HISTORIC AND DESIGN REVIEW COMMISSION

HDRC CASE NO: 2017-522
ADDRESS: 401 E LOCUST
LEGAL DESCRIPTION: NCB 1737 BLK 6 LOT 7 (CARLA HILLS)
ZONING: MF-33,H
CITY COUNCIL DIST.: 1
DISTRICT: Tobin Hill Historic District
APPLICANT: Varco Builder of Texas LLC
OWNER: Brian Correa
TYPE OF WORK: Install river rock in front yard; Front Yard Fence; Carport
REQUEST:

The applicant is requesting a Certificate of Appropriateness for approval to:

Patio EXPANSION & COVER
Proposal 1

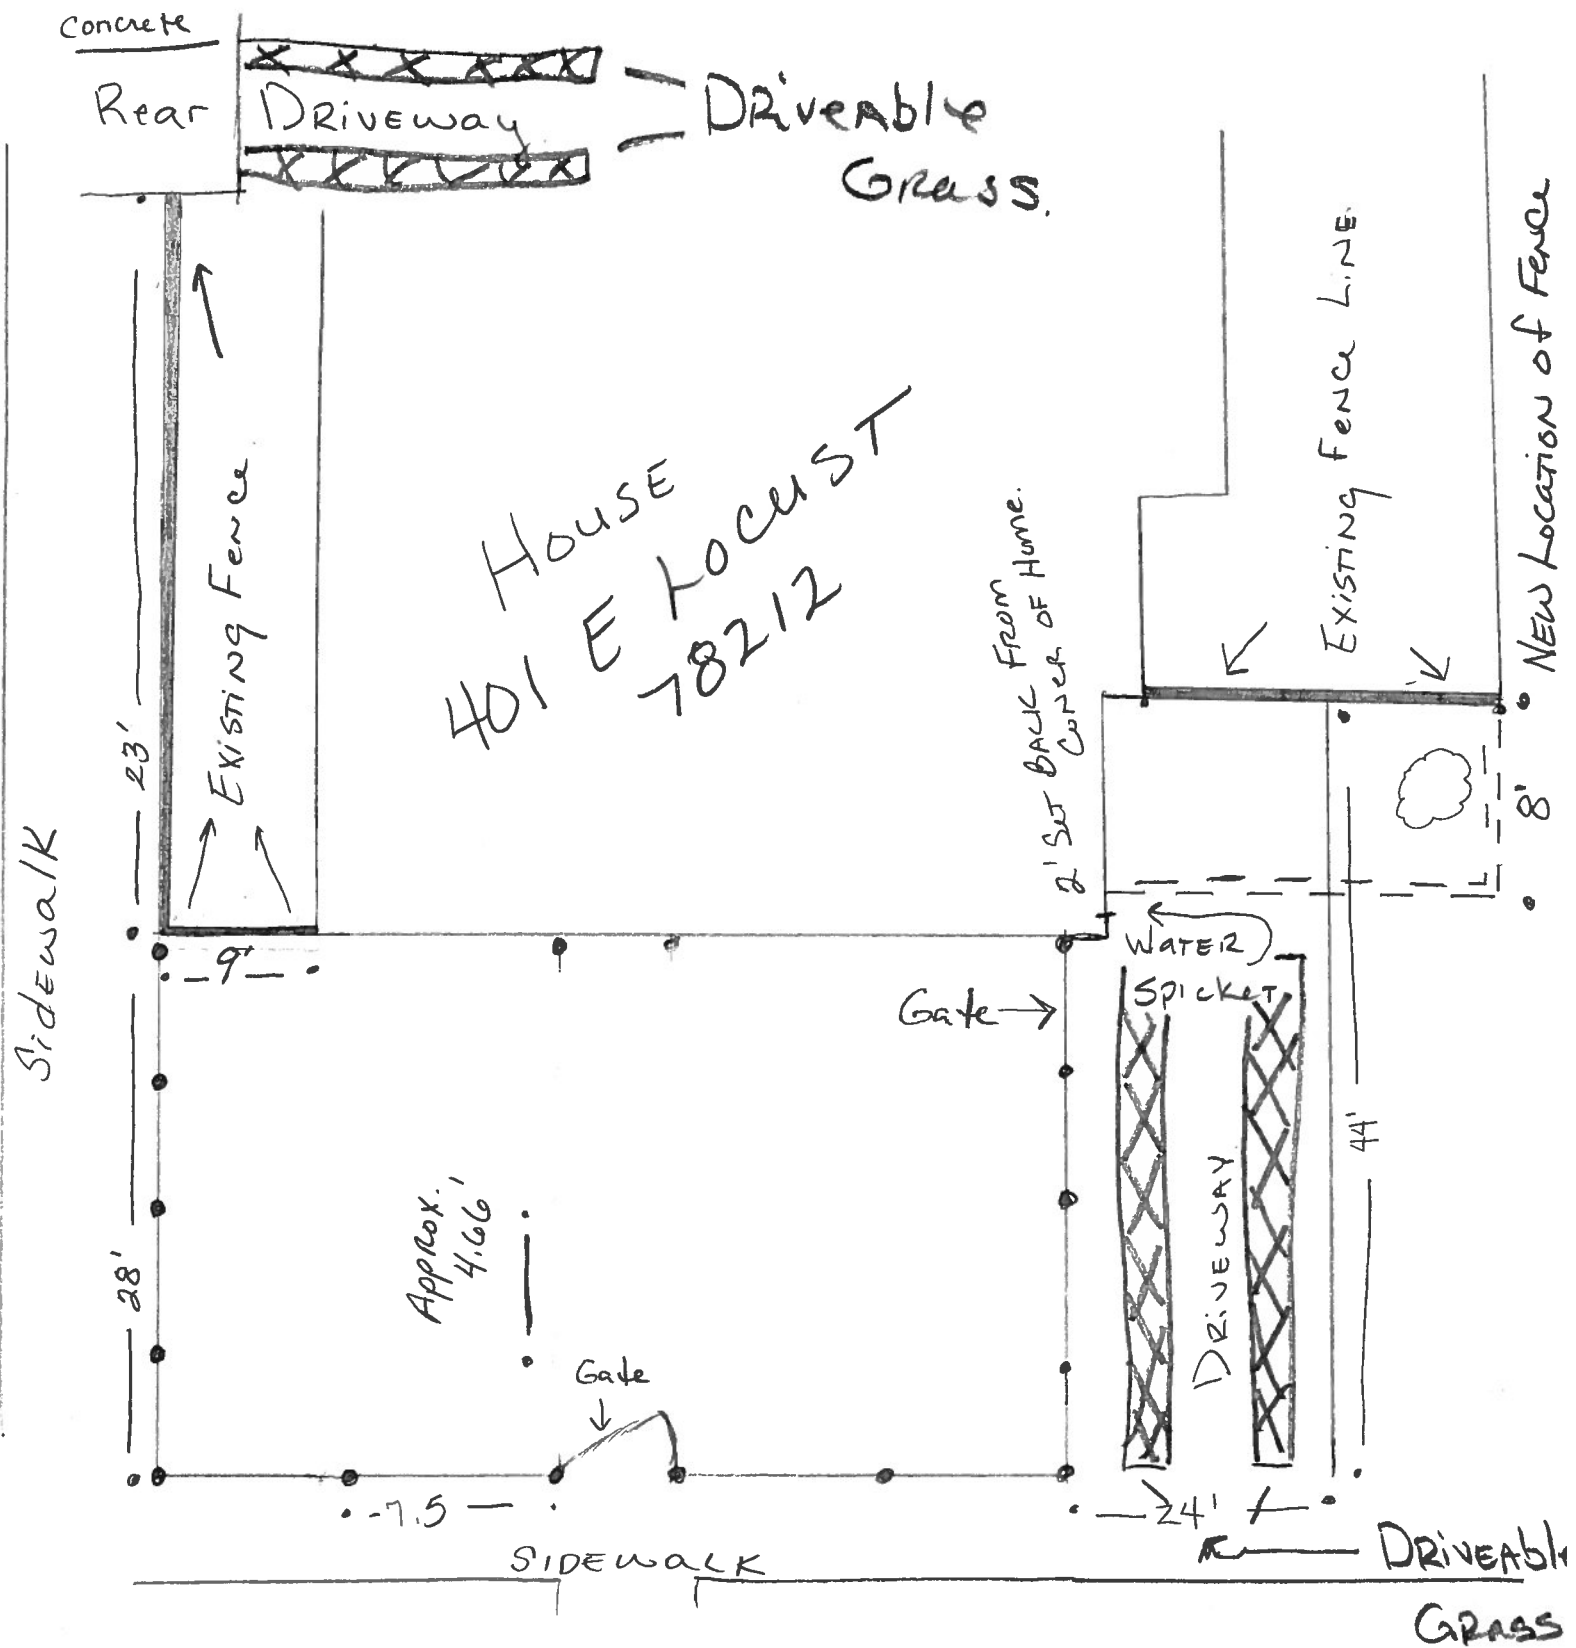
- f. REAR DECK – The applicant has proposed to expand the existing covered 15-foot by 16-foot deck with an uncovered 14-foot by 16-foot deck. The proposed deck will match the existing deck in height, railing detail, and material. The wood steps will be relocated accordingly. The proposed deck expansion will not be seen from Locust Street since it is hidden behind an existing privacy fence. Guidelines 2.7.B.iv notes that alterations to side and rear porches should result in a space that functions and is visually interpreted as porch. Staff finds the proposed deck expansion appropriate.

5. Cedar Cattle gate to enclose front yard is correct.
6. The tree will not be removed but instead will be incorporated in the deck with a circular bench framing in the tree. The tree will have room to grow so as not to interfere with the deck in the future.
